## 8787 Georgia Avenue Sketch Plan No. 320170060

Completed: 7/14/17

### Summary

- Staff recommends approval of the 8787 Georgia Avenue Sketch Plan with conditions.
- The project will redevelop the site with a mixed-use building including 12.5% moderately priced dwelling units, structured parking, and a new through-block connection.
- The site previously received Planning Board approval on June 5, 2014 as Mandatory Referral MR2014047, which permitted the disposition of County property and approved the Preliminary Forest Conservation Plan and Tree Variance.
- On May 25, 2017, the Planning Board extended the 90-day Sketch Plan review period to July 22, 2017, pursuant to Section 59.7.3.3.C of the Zoning Ordinance. The Planning Board extended the Sketch Plan review period a second time, on July 13, 2017, through July 25, 2017 to accommodate a change in the Planning Board's agenda.

Figure 4: Building Section with Surrounding Context

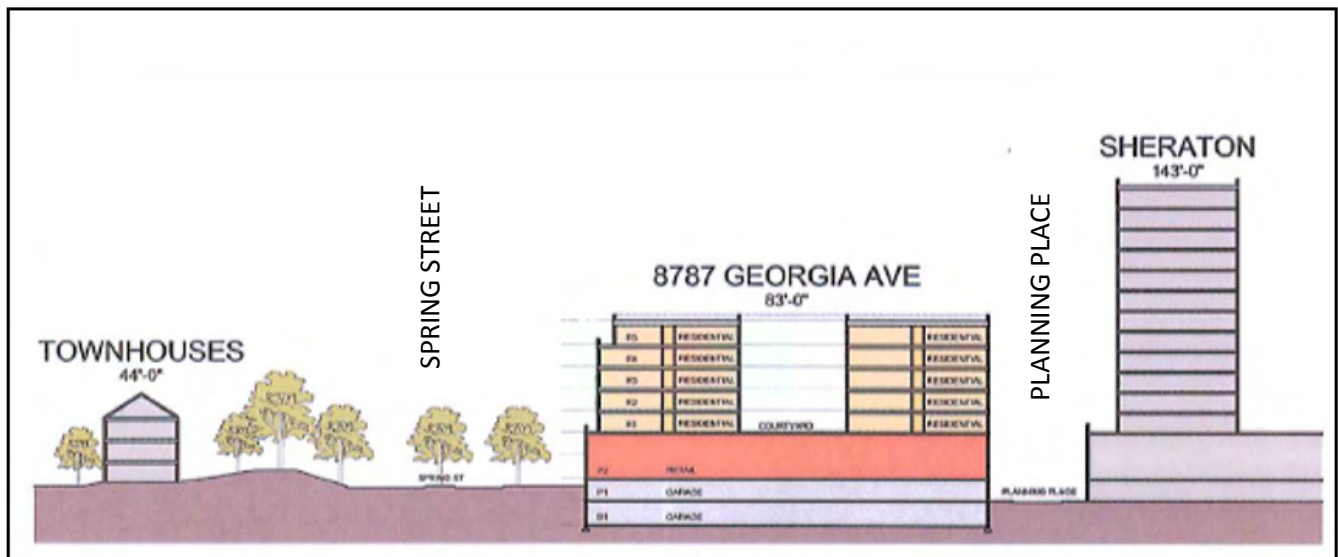
- Provide a transition between the lower density residential neighborhood to the north and tall buildings to the south, specifically incorporating building articulation, comprised of both horizontal and vertical façade breaks, to reduce the building mass when viewed from the north.

- Provide an architectural element, such as a tower or a bay, to terminate the view from Woodland Drive, looking south into the development, near the pedestrian mews.

- Present an active façade along the park frontage with shallow front stoops, interesting building articulation, and a green corner with a secondary residential lobby at the building corner closest to the Planning Place extended intersection at Spring Street.

Figure 5: Staff Proposed Alternative

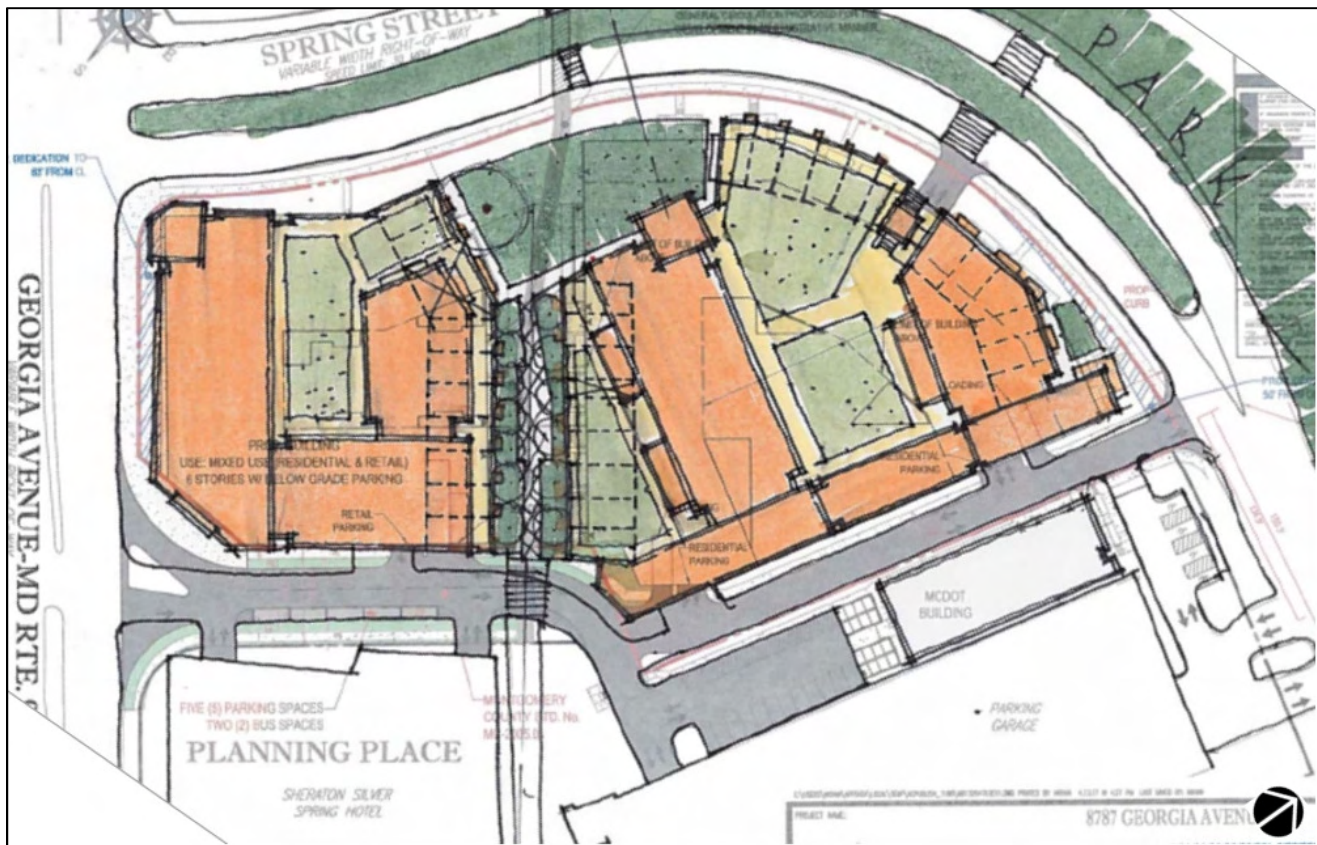
Staff developed an alternative design for the Site that maintains the same density as that proposed by the Applicant, but begins to address the issues raised by Staff and members of the public. Staff’s alternative design is presented in Figures 5 and 6, and the Applicant’s revised design (in response to Staff’s alternative) is presented in Figure 7. Although the Applicant’s revised plan was submitted after the final Sketch Plan submittal, dated May 19, 2017, it is included in this staff report to show progress between Planning Staff and the Applicant as the Project moves forward. Design elements enumerated in this report are recommended as conditions of approval for inclusion in subsequent building design. For the purposes of the public hearing, the drawings received on May 19, 2017 represent the submittal subject to the Planning Board’s review.

- Break-up the massing along Spring Street,
- Increase light and air into the interior public spaces,
- Embrace Fairview Park, and
- Eliminate a proposed driveway on Spring Street.

In response to Staff's alternative design, the Applicant revised their proposal to:

- Reorient the western building toward the Sheraton hotel to the south,
- Improve the relationship between the Project and Fairview Park through building articulation,
- Consolidate internal access points on Planning Place (though the Spring Street access point remains)

Staff remains concerned about the proposed Spring Street access point and the Project's design as it relates to the mews and adjacent uses, however, the Project as conditioned satisfies the intent of the Sketch Plan. The site layout and building design will be further refined during the Site Plan review with careful consideration of the Project's relationship as a project on the edge of the CBD and a prominent gateway.

Figure 17: Proposed Sketch Plan (P2 Level), as submitted May 19, 2017.

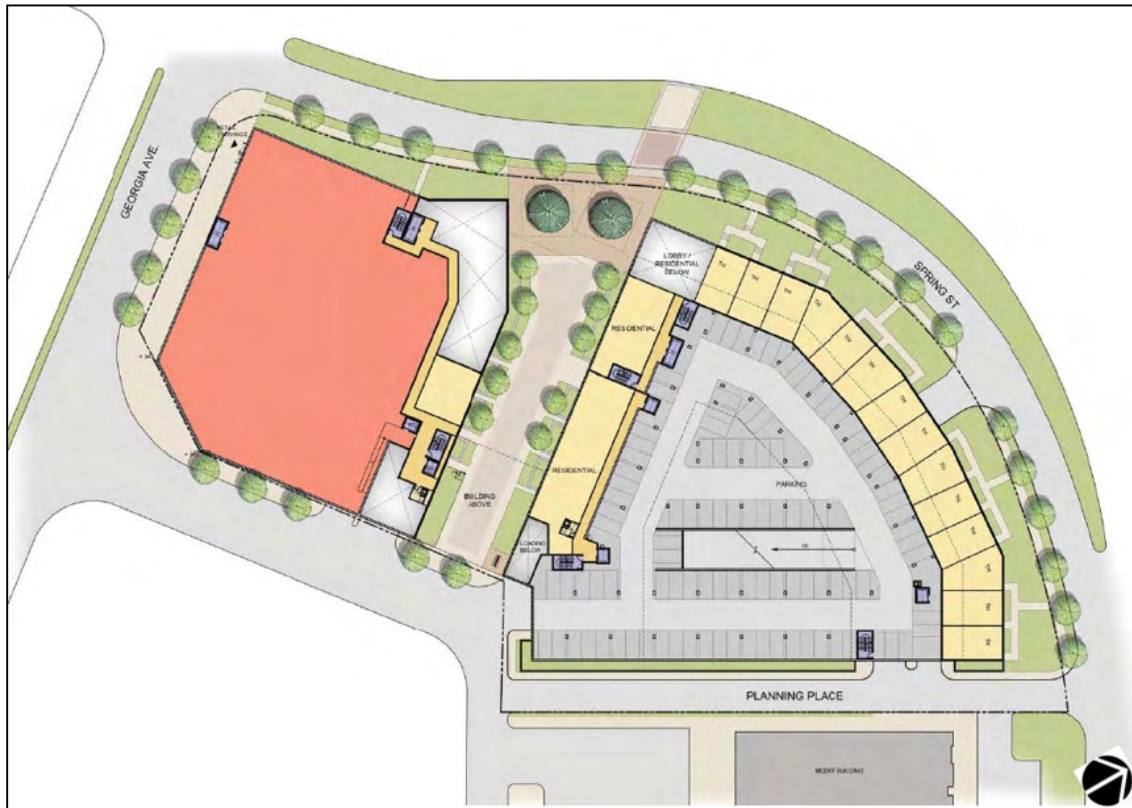
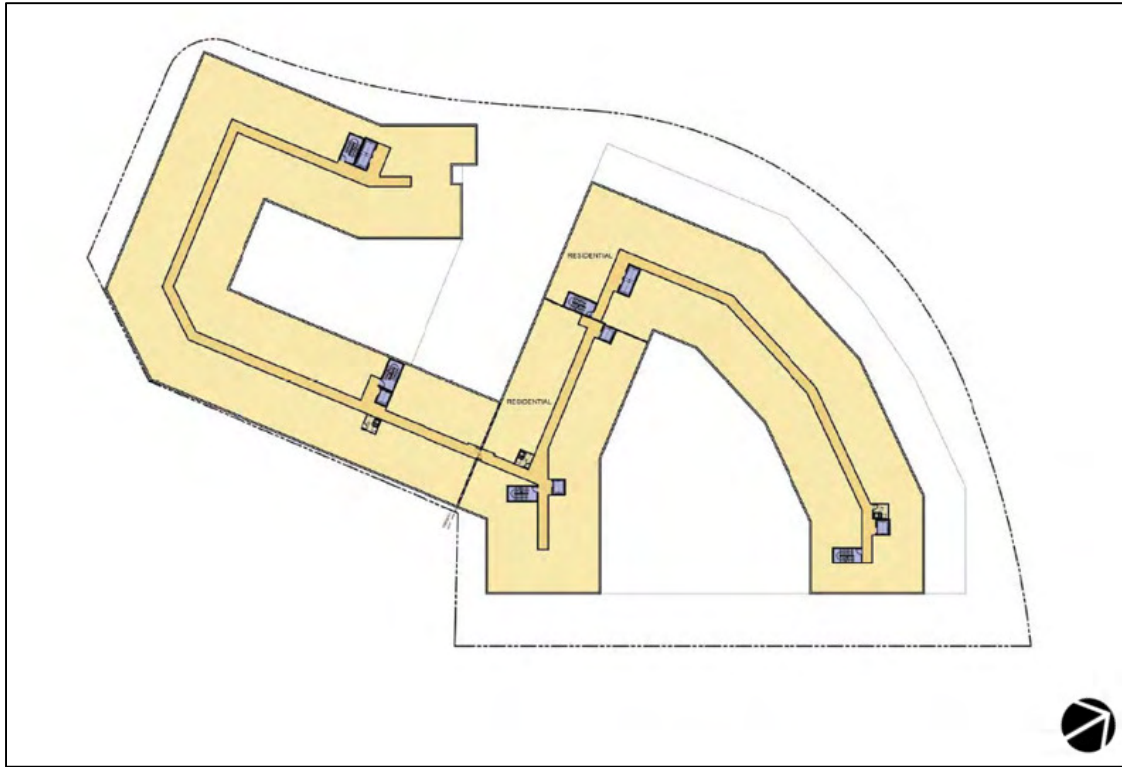
As submitted, in the Sketch Plan dated May 19, 2017, the building presents an imposing mass along Spring Street and lacks articulation and activation along the mews. As conditioned, the development will create an attractive pedestrian environment defined by well-designed buildings providing pedestrian residential, retail, and service entrances, open space connections, and other visual interest. A central landscaped mews will be accessible from the three surrounding streets and will provide a portion of the Silver Spring Separated Bicycle Network. The building height will be stepped-back along Spring Street to provide a transition from the single-family residential neighborhood to the north and the taller commercial and mixed-use buildings in the core.

As submitted, in the Sketch Plan dated May 19, 2017, the Project circulation concept creates the potential for conflict points at the intersection of Planning Place extended and a new mid-block access point on Spring Street. As conditioned, the development will provide safe and efficient site access and circulation as Staff recommends all vehicular access points should be from Planning Place. Although streetscape specifications will be finalized at the site plan stage, the Project will include appropriate streetscape elements, including the undergrounding of overhead utility lines.

As submitted, in the Sketch Plan dated May 19, 2017, the Project lacks a relationship with Fairview Park and does not effectively provide formal and informal gathering spaces due to the mass of the building façade opposite the park. As conditioned, the Project should embrace Fairview Park by providing a building that activates and contributes to the parkland through the use of architectural elements and pedestrian connections. The Project will provide a high quality public open space, in the form of the through-block mews and small parklet along Spring Street, that will upgrade the indoor and outdoor areas of the Project that will facilitate a connection to

Figure 21: Open Space Exhibit

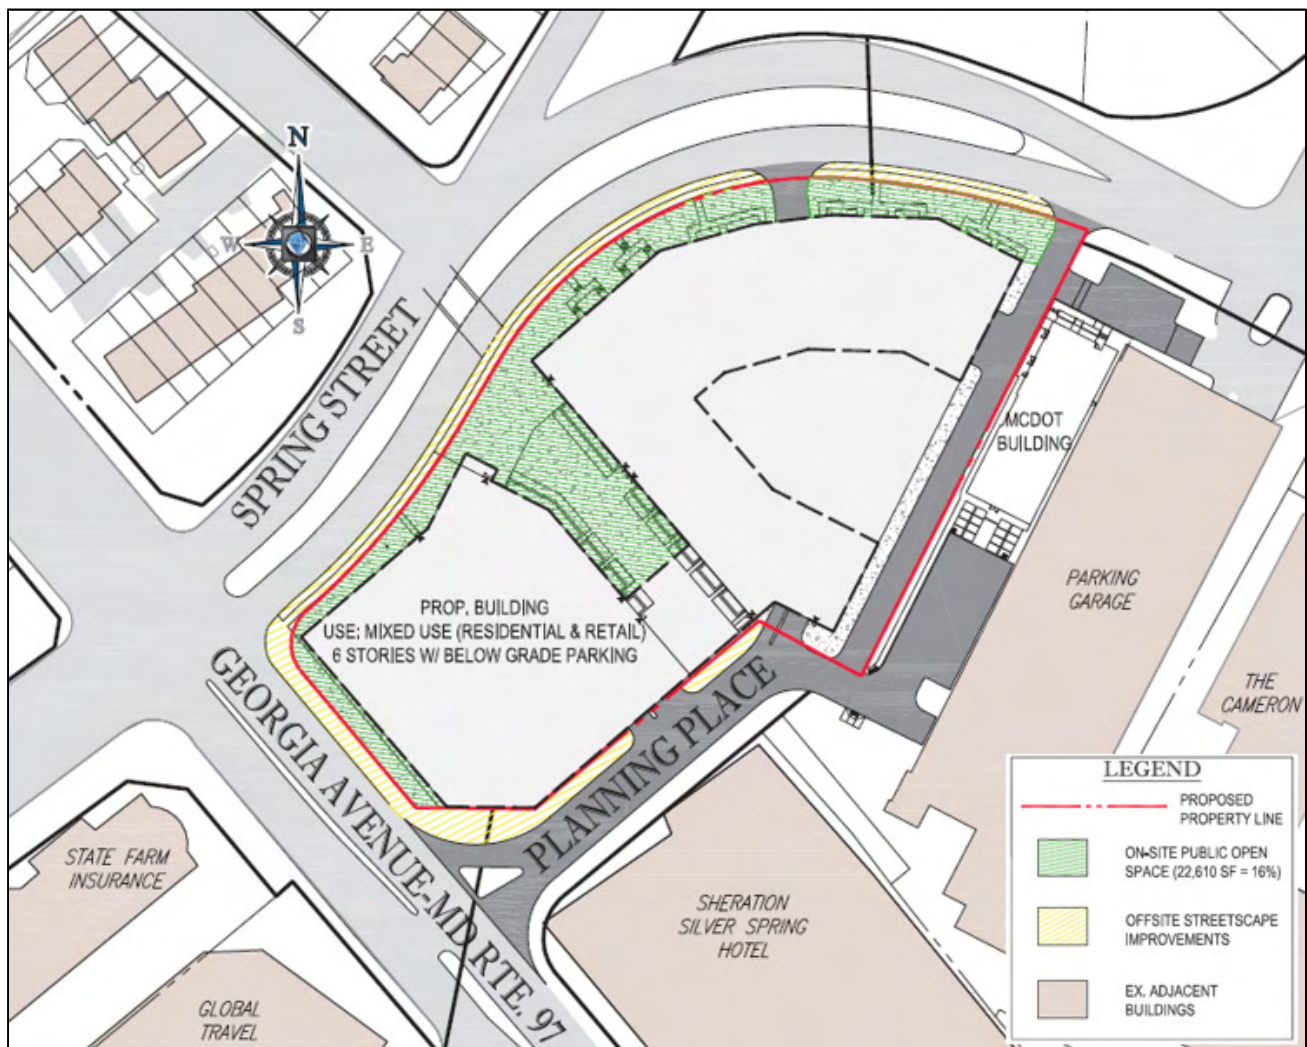
In the Sketch Plan submission, the Applicant is proposing to take credit for the open space area that would generally be recognized as the front yards of the units that open directly onto Spring Street. Staff has advised the Applicant that this is not acceptable and they are working to revise the design to provide the required amount of public use space.

Figure 26: Staff Proposed Alternative

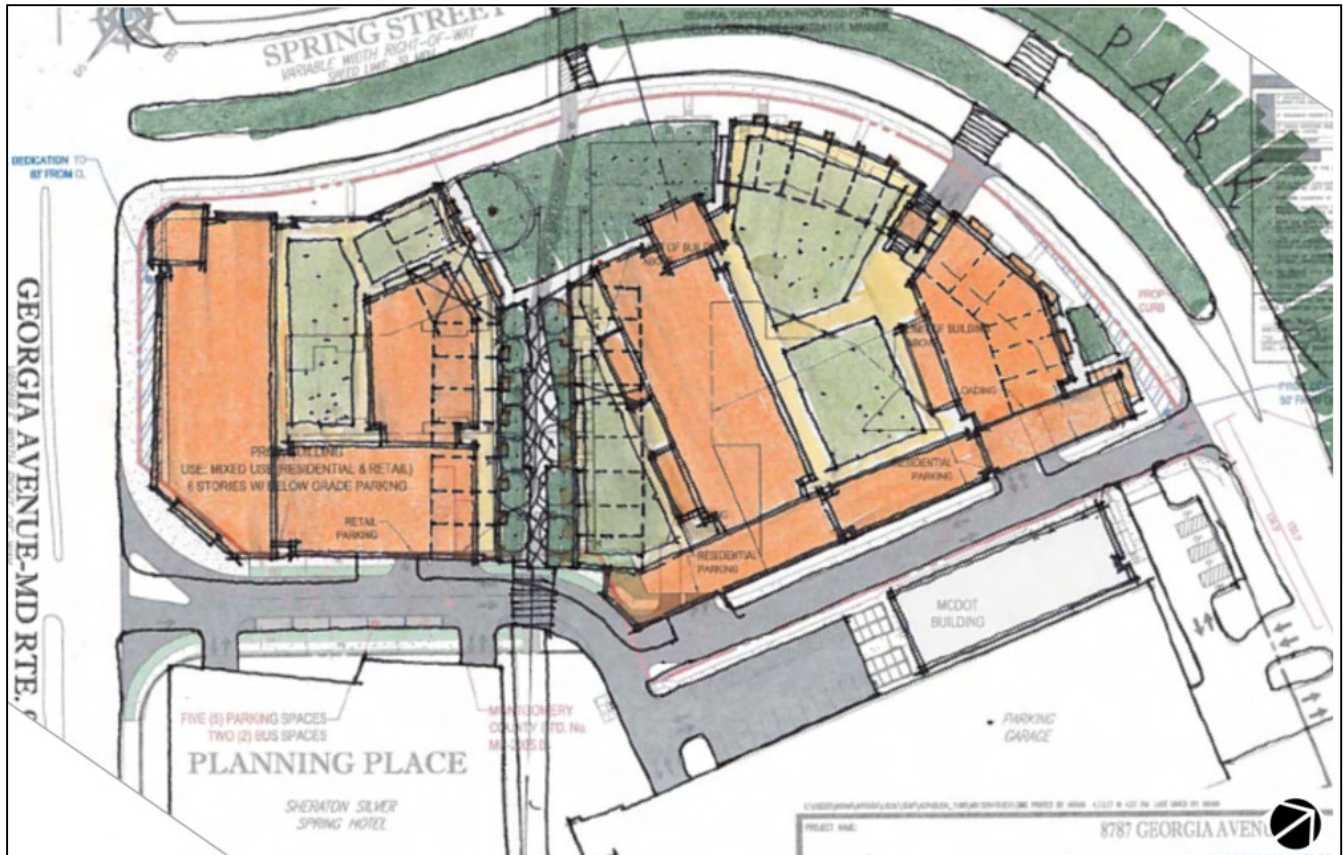
Staff developed an alternative design for the Site that maintains the same density as that proposed by the Applicant, but began to address the issue raised above. Staff held a number of design meetings with the Applicant team on June 7<sup>th</sup> and June 14<sup>th</sup> 2017 to discuss potential changes for consideration at the time of Site Plan review. A summary of those designs (Figures 26 and 27), as well as the Applicant's revised plan (Figure 28) is discussed below. Although the Applicant's revised plan was submitted after the final Sketch Plan submittal, dated May 19, 2017, it is included in this staff report to show progress between Planning Staff and the Applicant as the Project moves forward. Design elements enumerated in this report are recommended as conditions of approval for inclusion in subsequent building design.

Staff's alternative design is intended to break-up the massing along Spring Street, increase light and air into the interior public spaces, embrace Fairview Park, and eliminate a proposed driveway on Spring Street. The idea of breaking up building massing is a 3-Dimensional proposition that should include vertical building breaks as well as horizontal step-backs and projections. Staff's design also eliminates the upper story breezeway over the pedestrian mews, which creates a heavy and somewhat oppressive perception in an otherwise open and inviting public open space. Although the Applicant's revised design includes two- to three-story multi-family dwelling units with street activating features to enliven the public realm, the singular horizontal step-back is insufficient to articulate what appears to be a monolithic building. Staff's proposed alternative design embraces Fairview Park by creating an opening and staircase from the upper courtyard and lines Spring Street with human scale two- to three-story multi-family dwelling units.

In response to Staff's alternative design, the Applicant revised their proposal in a manner than incorporated some, but not all, of Staff's alternatives. The most significant change to the site design following Staff's alternative was reorientation of the western building toward the Sheraton hotel to the south. This change pushes the mass of the Project toward the CBD and presents the narrow ends of the building wings to the Woodside Park neighborhood. With this horizontal relief between the wings, the overall mass of the larger building is broken down and fragmented when viewed from across Spring Street. This orientation also allows the short end of the residential building wing to face onto Georgia as a singular monumental gateway element. The design will be further refined during the Site Plan review with careful consideration of the Project's relationship as a project on the edge of the CBD and a prominent gateway.
